EXPLANATION OF SIGNIFICANT DIFFERENCES

GEDDES BROOK/NINEMILE CREEK SITE

Operable Unit of the Onondaga Lake Bottom Subsite Onondaga Lake Superfund Site

Town of Geddes / Onondaga County / Site No. 734030 Operable Unit 1 / September 2013

FIGURE 3

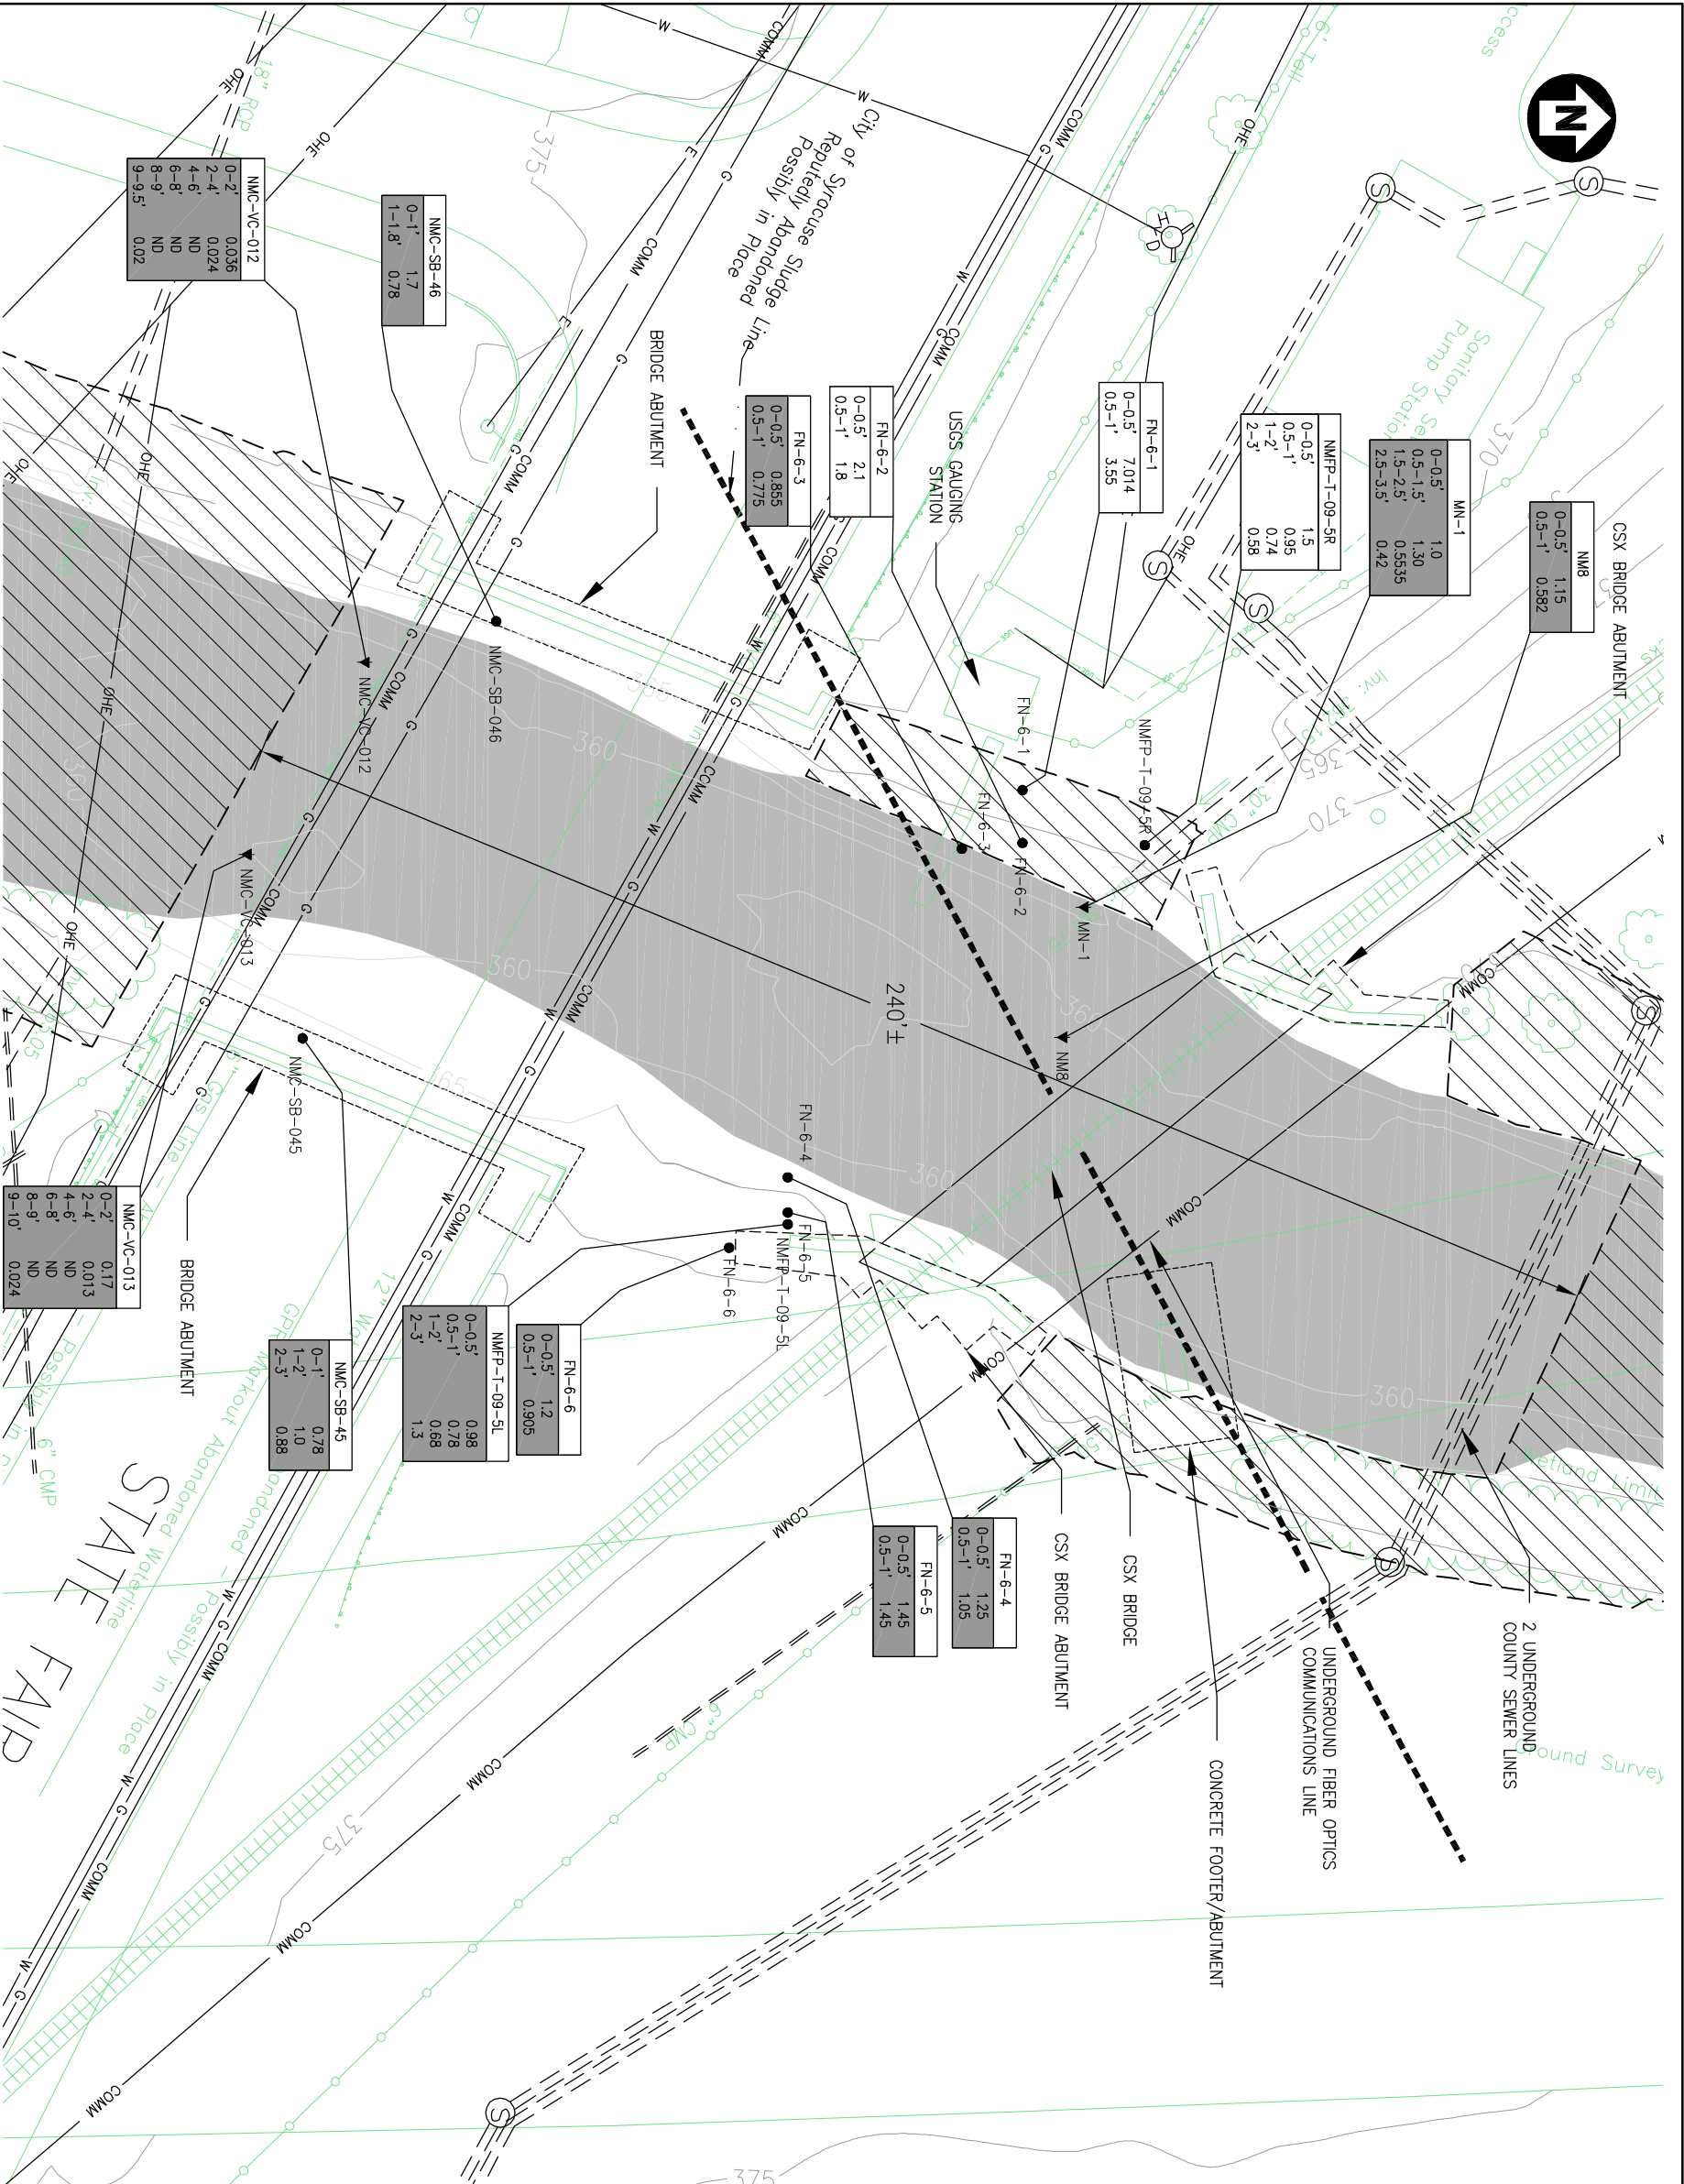
A total of 43 sediment and soil samples (not including duplicates) from within the 240-ft long stretch were collected at depths up to ten ft prior to and during the remedial design. The analytical results for the affected area (see Figure 3) indicate that the mercury concentrations in all channel sediment samples did not exceed the NYSDEC Severe Effect Level (SEL) of 1.3 milligrams per kilogram

(mg/kg) and seven of the 18 sediment samples exceeded the Low Effect Level (LEL) of 0.15 mg/kg. In addition, the concentrations of other CPOIs in channel sediment within the 240-ft section were below the NYSDEC sediment screening criteria values presented in the ROD. Floodplain soil concentrations for mercury within the 240-ft section were generally low except for three locations on the west bank between the State Fair Boulevard and CSX bridges where mercury was detected up to 7 mg/kg. These areas will be remediated under the modified remedy. All contaminants other than mercury in floodplain soil were below their respective targets except for two sample locations on the east bank near the State Fair Boulevard and CSX bridges where the SEL for lead of 110 mg/kg was exceeded. These anomalous detections of lead may be because of anthropogenic sources (*e.g.*, the historic use of leaded gasoline) that are unrelated to former Honeywell operations.

A summary of the concentrations of mercury and other CPOIs from sampling locations (at all depths) in the channel and floodplain (as shown on Figure 3) within this 240-ft stretch that would not be removed is provided below.

It should be noted that data from three stations on the west bank are in an area that will be removed between the State Fair Boulevard and CSX bridges (sample locations FN-6-1, FN-6-2, and NMFP-T-09-5R) and therefore are not included in the above summary. For non-detectable concentrations, average values in the table above are based on the detection limits.

Figure 4
Focused Remedial Approach Summary

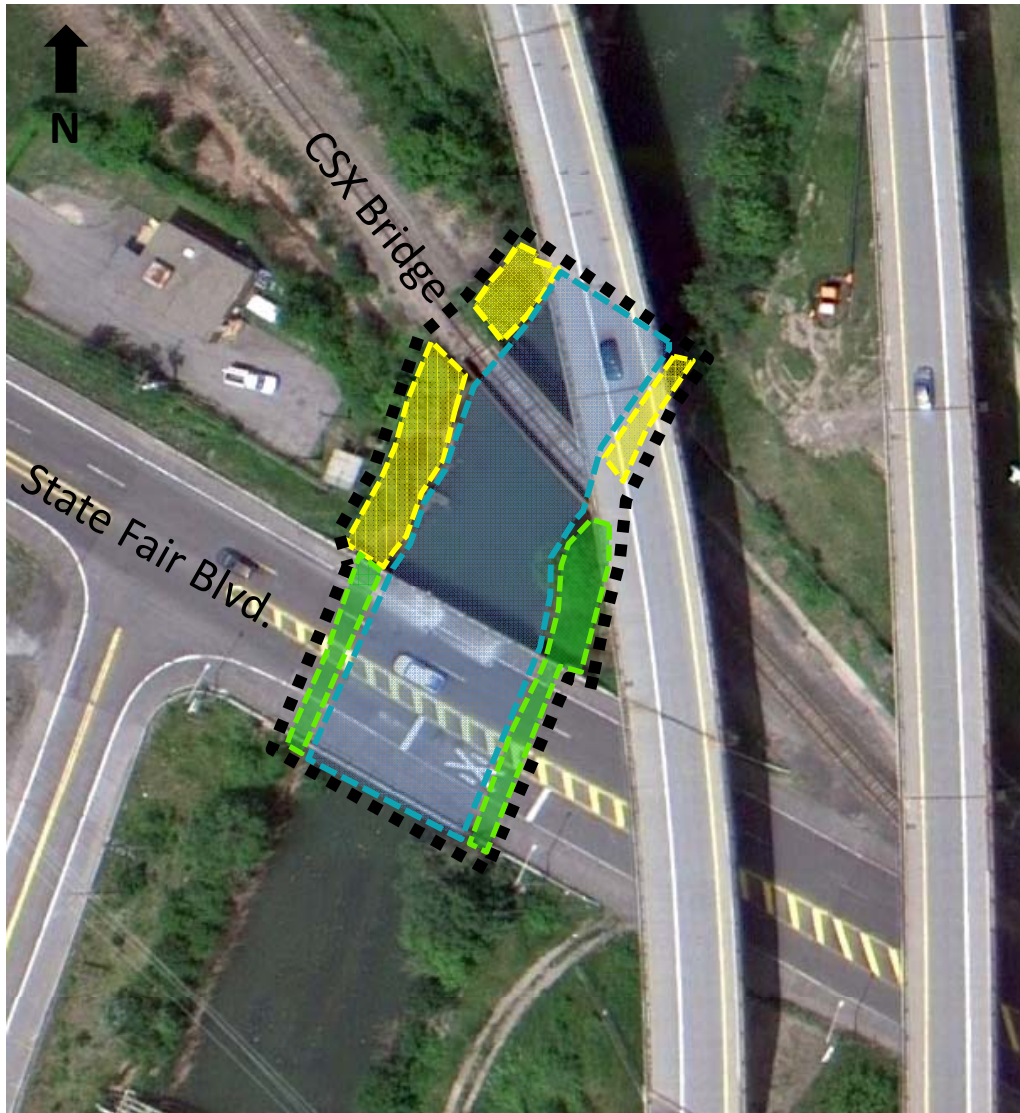
- Implementing area-specific soil/sediment removal for banks/floodplains (see Figure 4), consisting of:
 - No removal of floodplain soil/sediment on the east bank, between the State Fair Boulevard and CSX bridges because of access limitations discussed above and the fact that CPOI concentrations are relatively low, as discussed in the previous section.

- For the west and east bank floodplain soil/sediment, downstream of the CSX bridge, and on the west bank between the State Fair Boulevard and CSX bridges, soil/sediment overlying structural stone will be removed in three areas of elevated mercury concentrations, in a manner consistent with other Reach BC areas with structural stone. This excavation will take into consideration existing infrastructure (*e.g.*, bridge abutment associated with the on-ramp to I-695 south, sewer lines), such that materials within approximately five to ten ft of these structures will not be disturbed in order to avoid potential adverse structural impacts. Areas where soil removal will occur above structural stone will be restored, in general, through placing joint plantings in between adjacent stones. However, there may be areas with very gentle slopes, where up to 12 inches of topsoil (as determined in consultation with NYSDEC) will be placed over the structural stone prior to the installation of the plants.
